**RFP Title: GENERAL CONTRACTOR SERVICES FOR JOSLIN RECREATION CENTER CPF
IMPROVEMENTS**

Addendum #: 1

*****ADDENDUM ONE*****

**City of Providence
Department of Public Property
Joslin Recreation Center – CPF Renovation
17 Hyatt Street
Providence, RI 02903**

FRAME TYPES

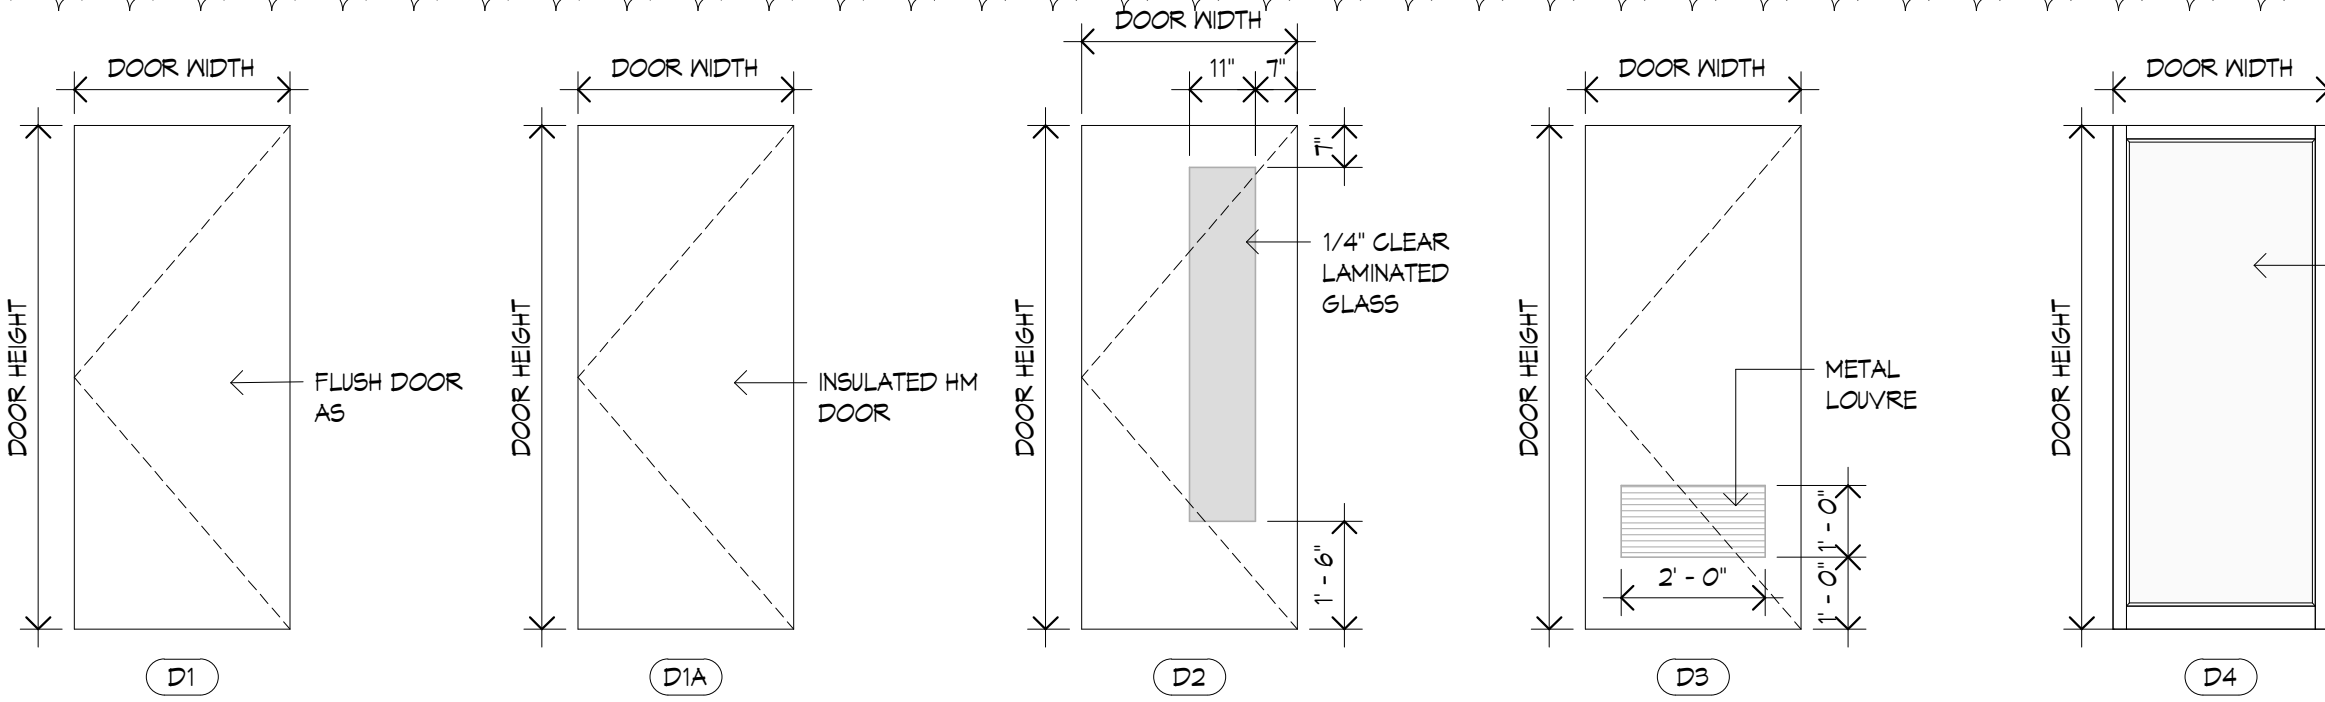
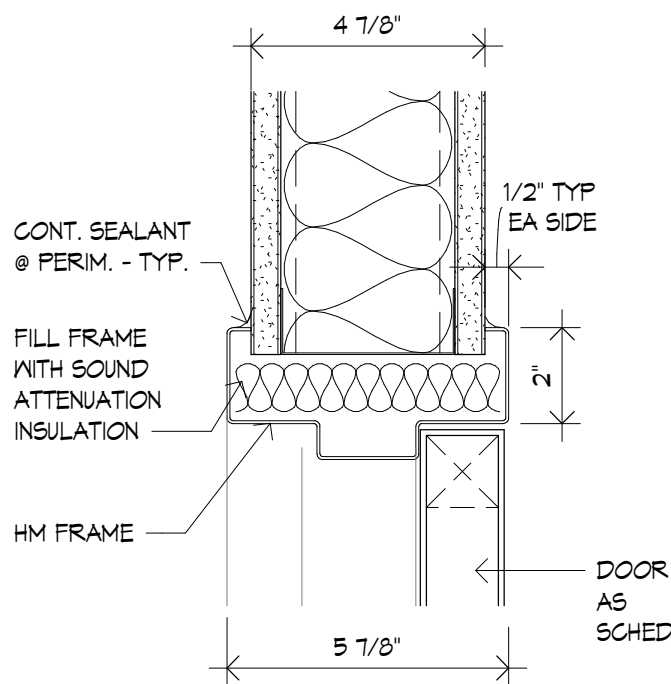
- Please clarify, on drawing A6.00 door schedule RM102 there is no frame type listed.

Answer – Door #102 into Storage Rm 102 will receive a New set of Fire Rated Doors and Fire Rated Hollow Metal Frame. Revised Drawing sheet A6.00 is included in this Addendum.
